New South Wales Government
Independent Planning Commission

Vickery Extension Project SSD 7480

Issues Report

30 April 2019

Figure 2: Simulated Water table drawdown (m) at the end of the Vickery Mining (Stress period 110) for the cumulative and borefield scenarios (Source: Vickery Extension Project Groundwater Assessment)

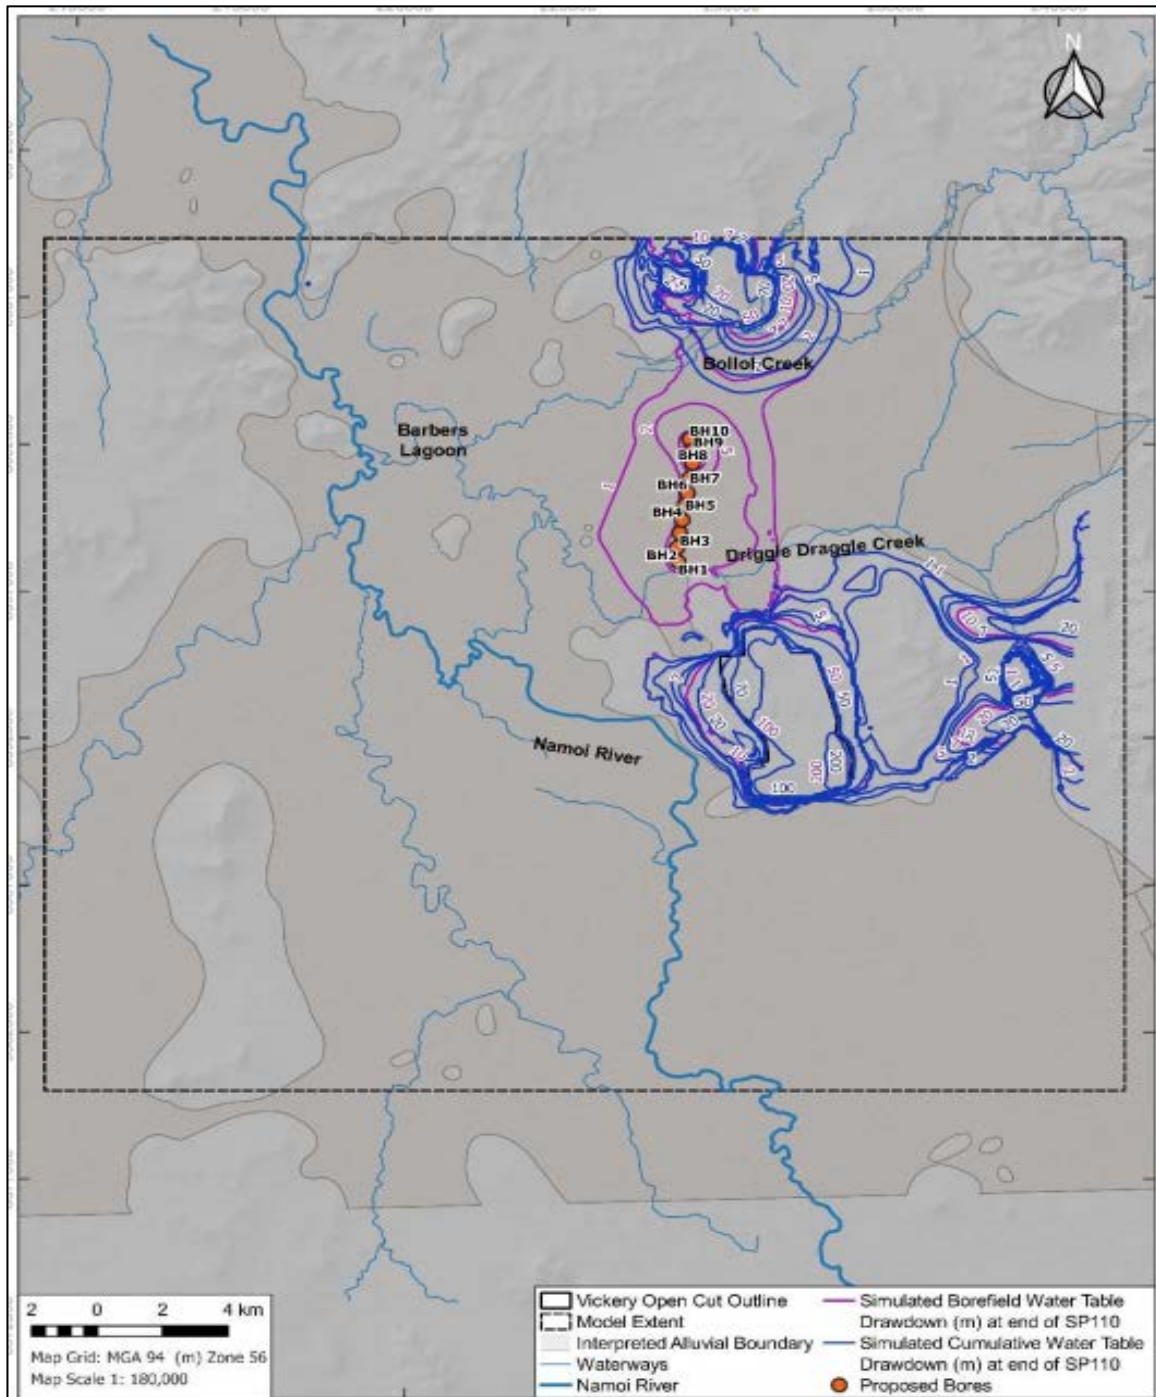
72. The Applicant’s groundwater assessment predicted groundwater drawdowns around the mine and borefield. This is presented in **Figure 2**. The Commission notes that these and other drawdown figures in the document do not indicate within which strata the drawdowns occur (i.e. in the Narrabri/Gunnedah formations and/or in the deeper fractured rock). The Commission considers that this information may be important for the Department to be able to assess the potential off-site impacts, as drawdowns in the Narrabri/Gunnedah

formations have the potential to impact on Groundwater Dependent Ecosystems (**GDEs**) in the region around the borefield. Additionally, as indicated in the IESC report, this potential has not been assessed in the EIS or the Preliminary Response to Submissions, so the Commission considers the current documentation appears insufficient for the Department to assess the potential impact of the borefield on GDEs, or to assess the amelioration methods that are proposed in the event of unavoidable impacts.
